To: T10 Technical Committee
From: Amr Wassal, PMC-Sierra (amr_wassal@pmc-sierra.com)
Date: 5 July 2006
Subject: 06-xxxx0 SAS-2: Modifications to the SAS Speed Negotiation

Suggested changes to chapter 6 (Phy Layer)

Figure 123 — SAS-2 G3 speed negotiation window

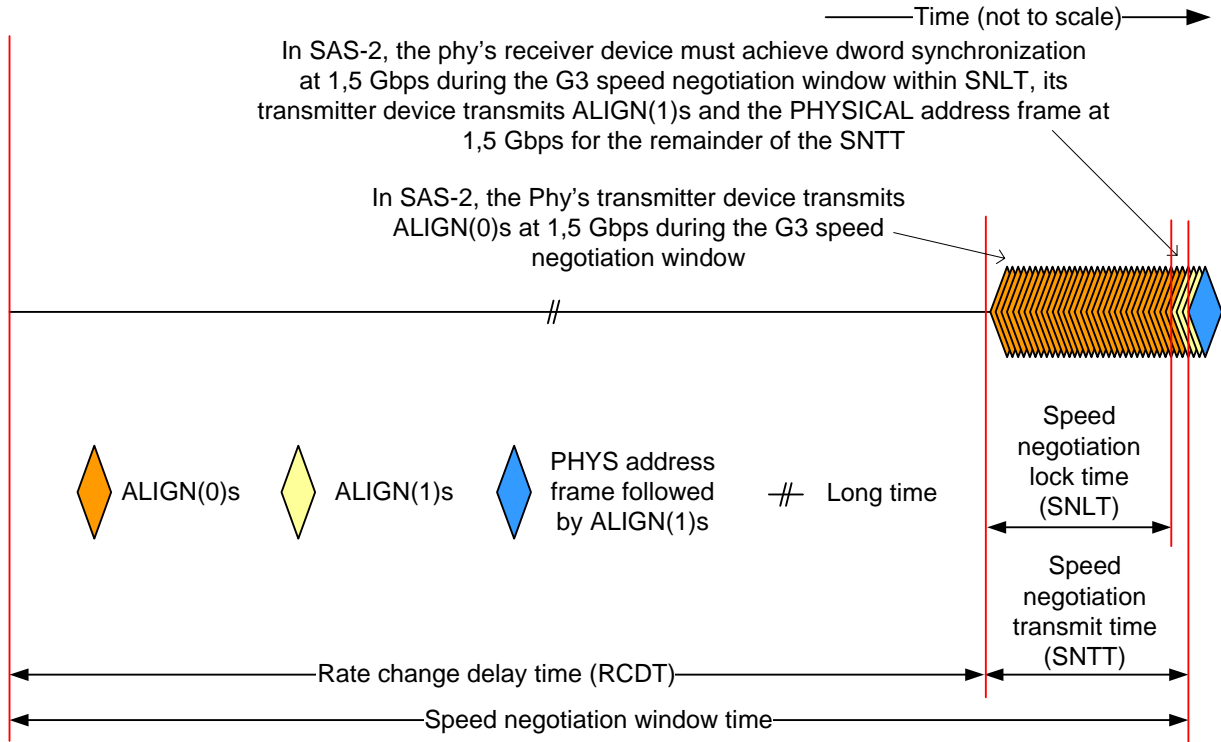
Figure 123 defines the SAS-2 G3 speed negotiation window, including:

- a) speed negotiation window time;
- b) speed negotiation window rate of 1,5 Gbps;
- c) rate change delay time (RCDT);
- d) speed negotiation transmit time (SNTT); and

e) speed negotiation lock time (SNLT).

The SAS-2 speed negotiation G3 window has the following differences compared to SAS-1 speed negotiation windows:

- 1) ALIGNs are sent at 1,5 Gbps instead of window rate; and
- 2) if the phy achieves dword synchronization to ALIGN (1) primitives, it transmits a PHYSICAL address frame (see 7.8.2) followed by more ALIGN (1) primitives for the remainder of SNTT; and
- 3) the phy must receive a valid PHYSICAL address frame after achieving dword synchronization to ALIGN (1) primitives, otherwise, the G3 window is considered to have failed.

Figure 124 — SAS-2 final speed negotiation window

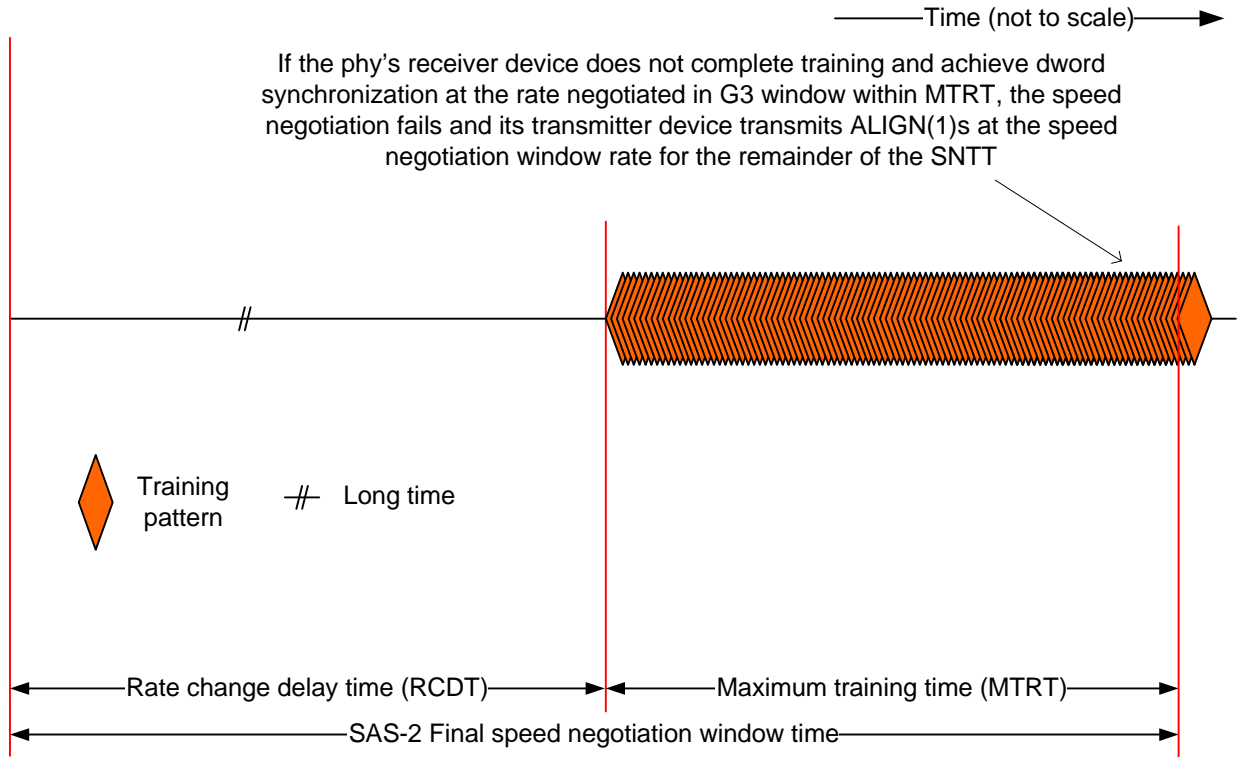
Figure 124 defines the SAS-2 final speed negotiation window, including:

- a) SAS-2 final speed negotiation window time;
- b) rate change delay time (RCDT); and

c) maximum training time (MTRT).

Figure 125 — SAS speed negotiation sequence (phy A: G1, G2, G3, phy B: G2 only)

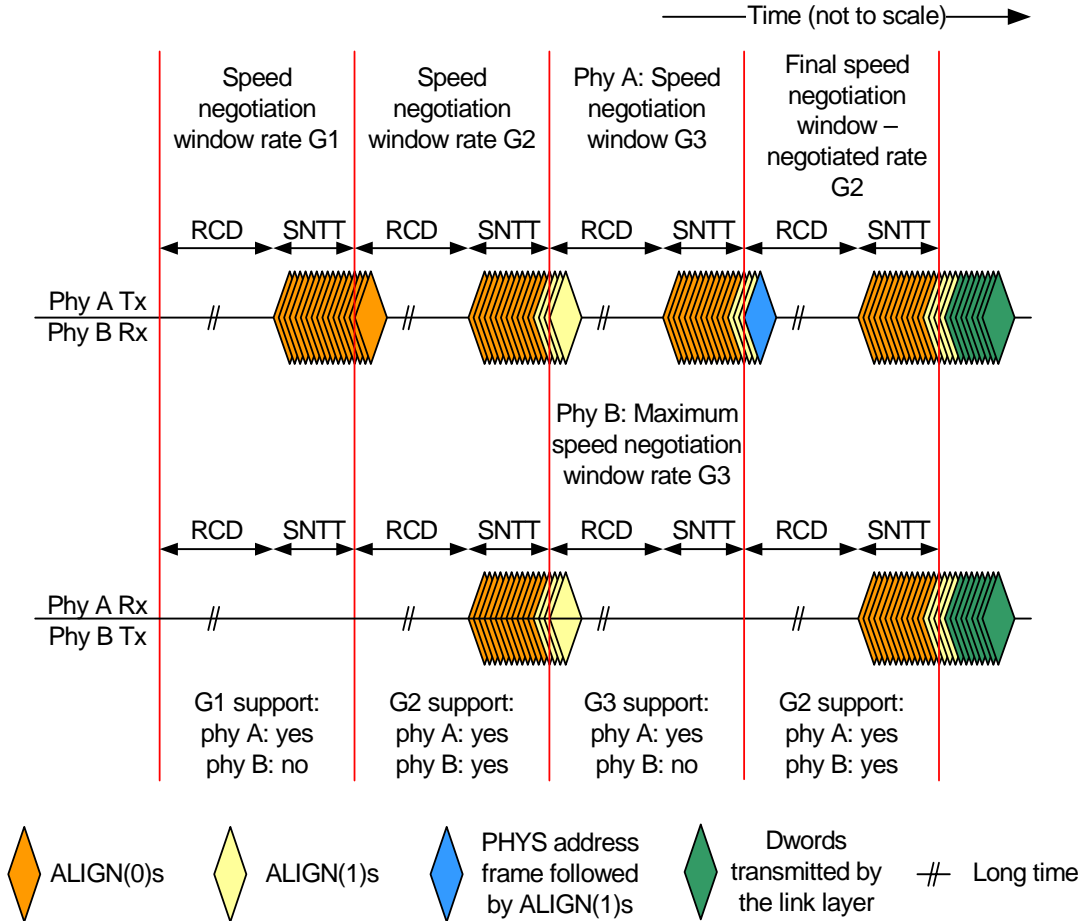
Figure 125 shows speed negotiation between a phy A that supports G1 through G3 and a phy B that only supports G2. Both phys run:

- 1) the G1 speed negotiation window, supported by phy A but not by phy B;
- 2) the G2 speed negotiation window, supported by both phys; and

3) the G3 speed negotiation window, supported by phy A but not by phy B.

Phy A reaches its limit because it has run a speed negotiation window that does not detect a valid physical link rate (i.e., G3) after having detected a valid physical link rate in a previous speed negotiation window (i.e., G2). Note that the ALIGNs are sent at G1 rate in the G3 speed negotiation window. Phy B reaches its limit because it has reached its highest support physical link rate plus one (i.e., G3). Both phys select G2 for the final speed negotiation window to establish the negotiated physical link rate.

Figure 127 — SAS speed negotiation sequence (phy A: G1, G2, G3 or higher, phy B: G1, G2, G3 or higher)

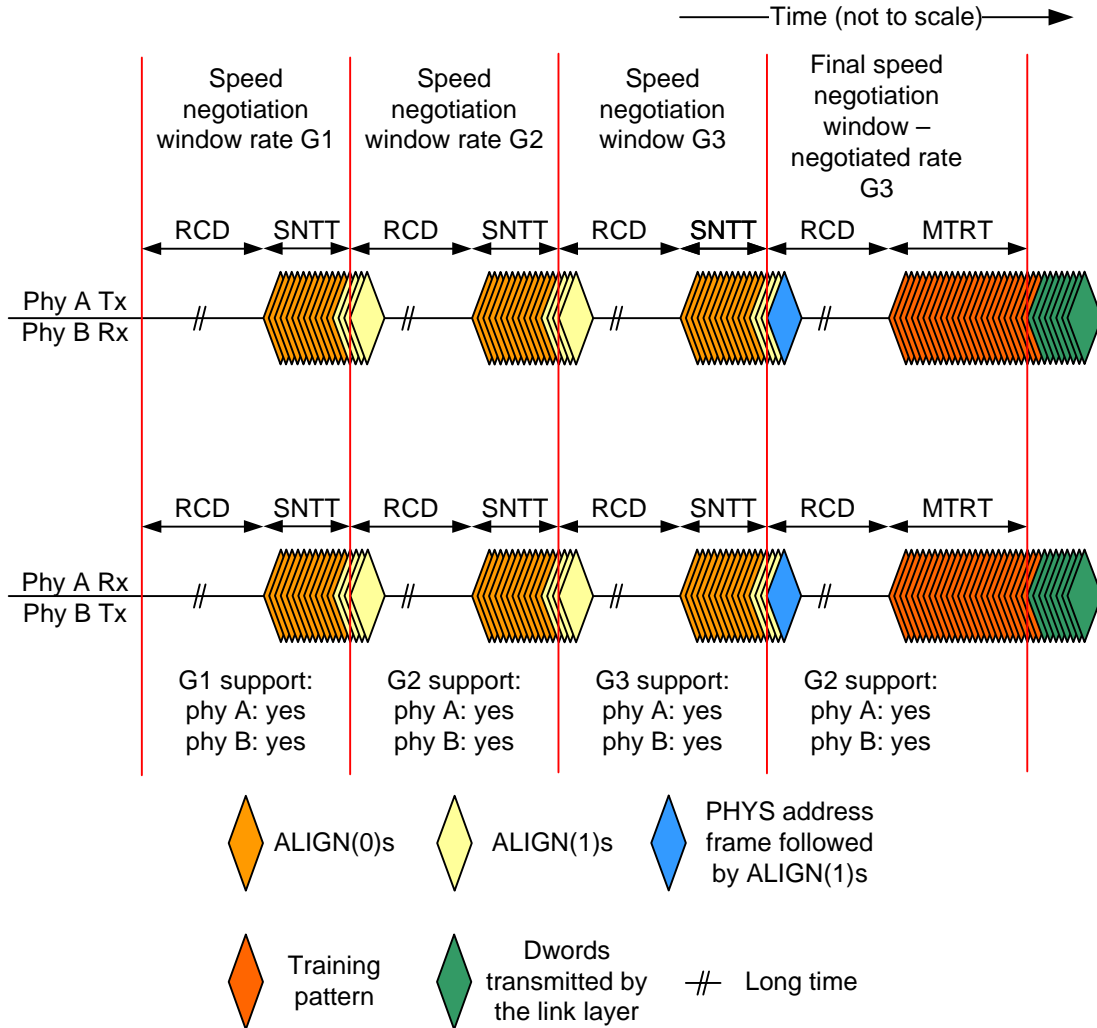
Figure 127 show speed negotiation between a phy A and a phy B that both support G3 rate or higher. Both phys run:

- 1) the G1 speed negotiation window, supported by both phys;
- 2) the G2 speed negotiation window, supported by both phys; and
- 3) the G3 speed negotiation window, supported by both phys where the PHYSICAL address frame is exchanged and the highest common rate supported by both phys is negotiated; and

4) the final speed negotiation window, supported by both phys where training is done.

Note that the ALIGNs are sent at G1 rate in the G3 speed negotiation window.

Figure 128 — SAS-2 speed negotiation sequence - G3 (maximum SNW) phy reset problem

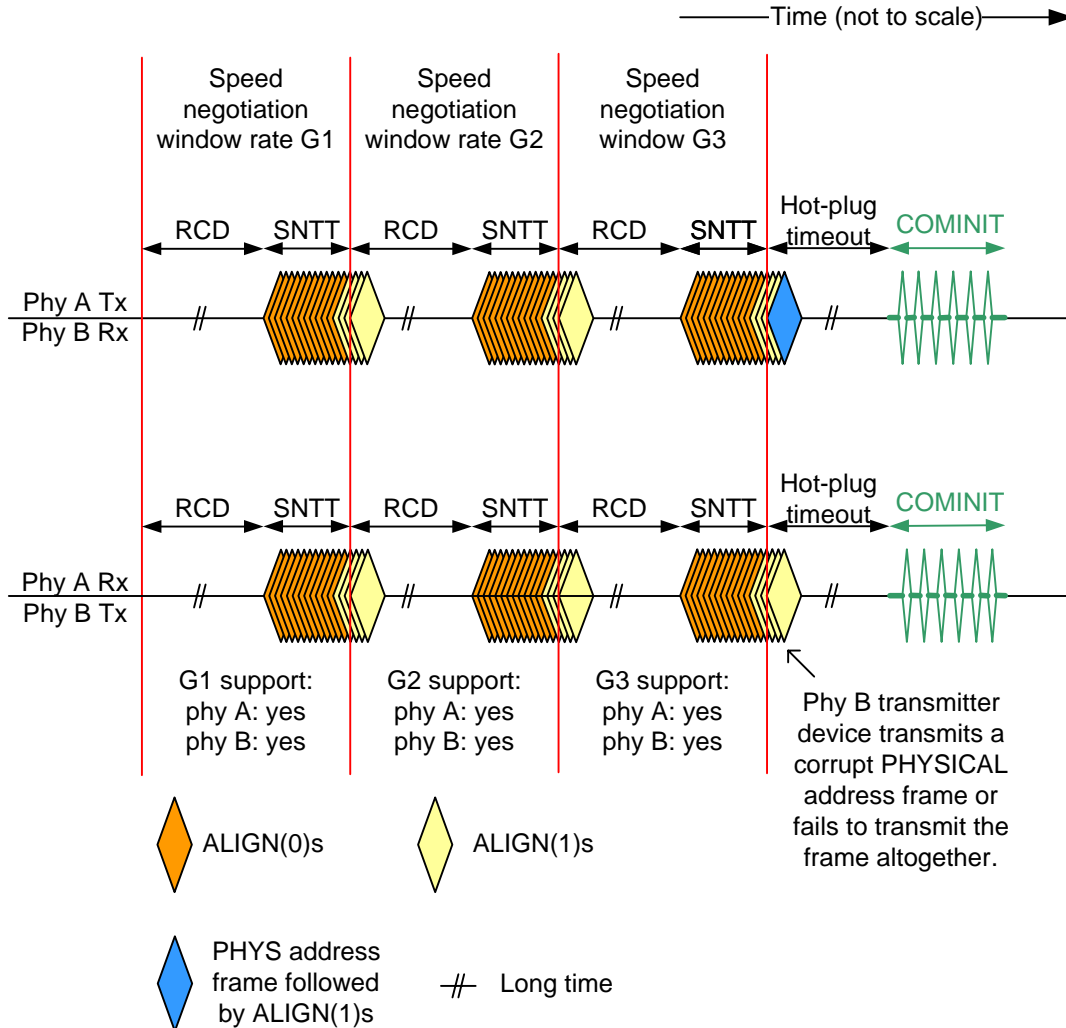
- 1) the phys do not exchange PHYSICAL address frames properly in G3 window (see Figure 128); or

Figure 129 — SAS-2 speed negotiation sequence - training (final SNW) phy reset problem

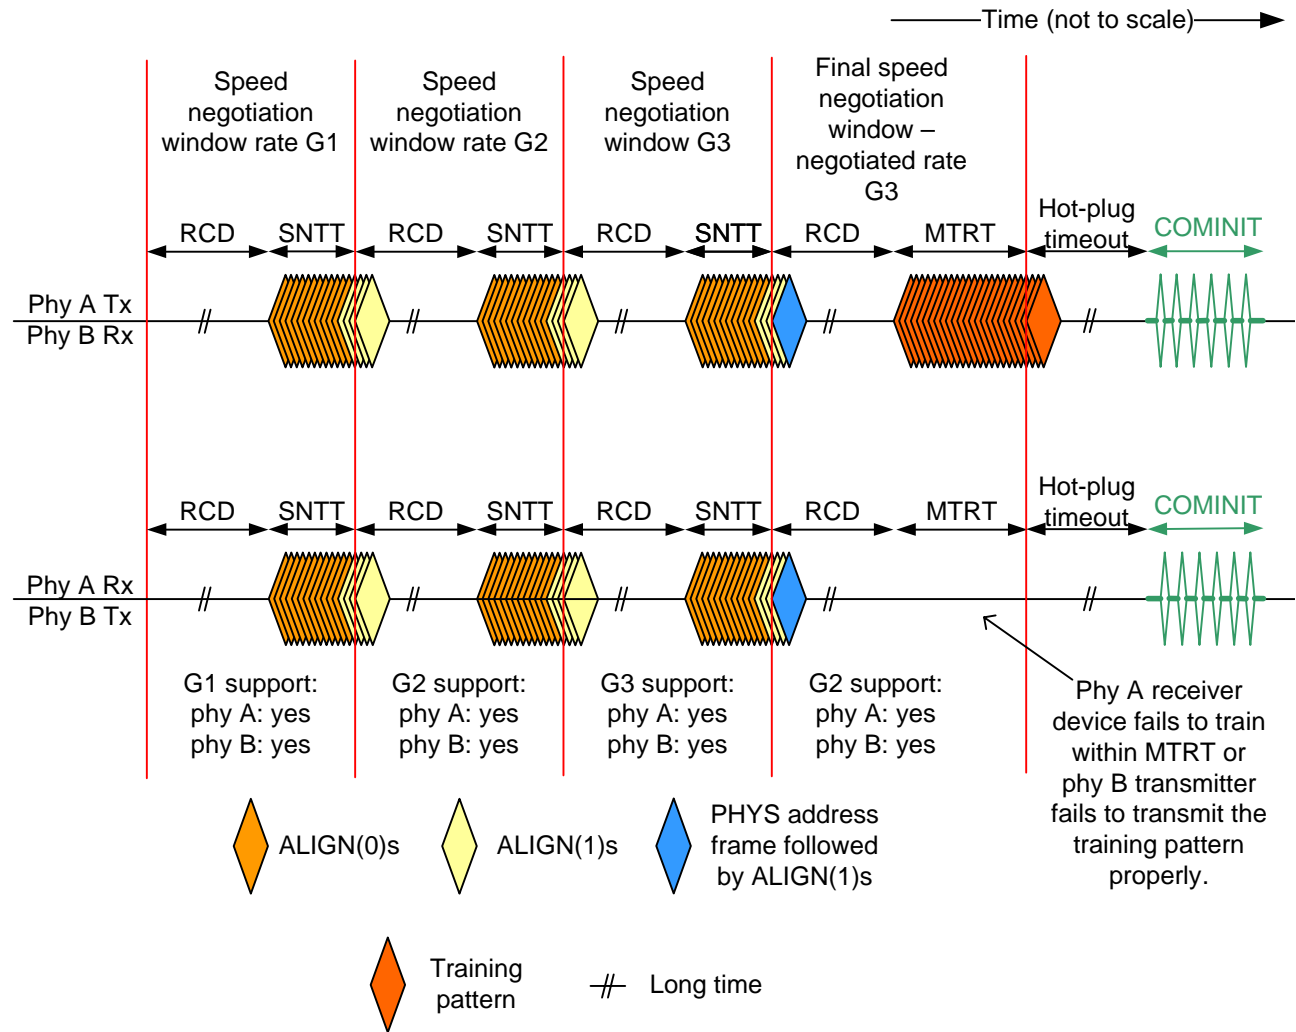
2) either phy does not complete training within the MTRT interval (see Figure 129)..
